Economic and Social Council

195th session

Proposal for the 03 series of amendments UN Regulation No. 92 (Replacement Exhaust Silencing Systems for Motorcycles)

Submitted by the Working Party on Noise and Tyres*

Figure 1

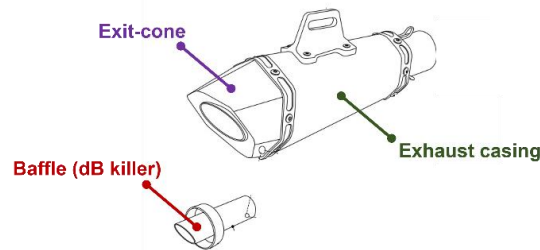
"2.8. “Exit-cone” means the final part of the exhaust silencing system outlet through which exhaust gases exit into the air (see figure 1).
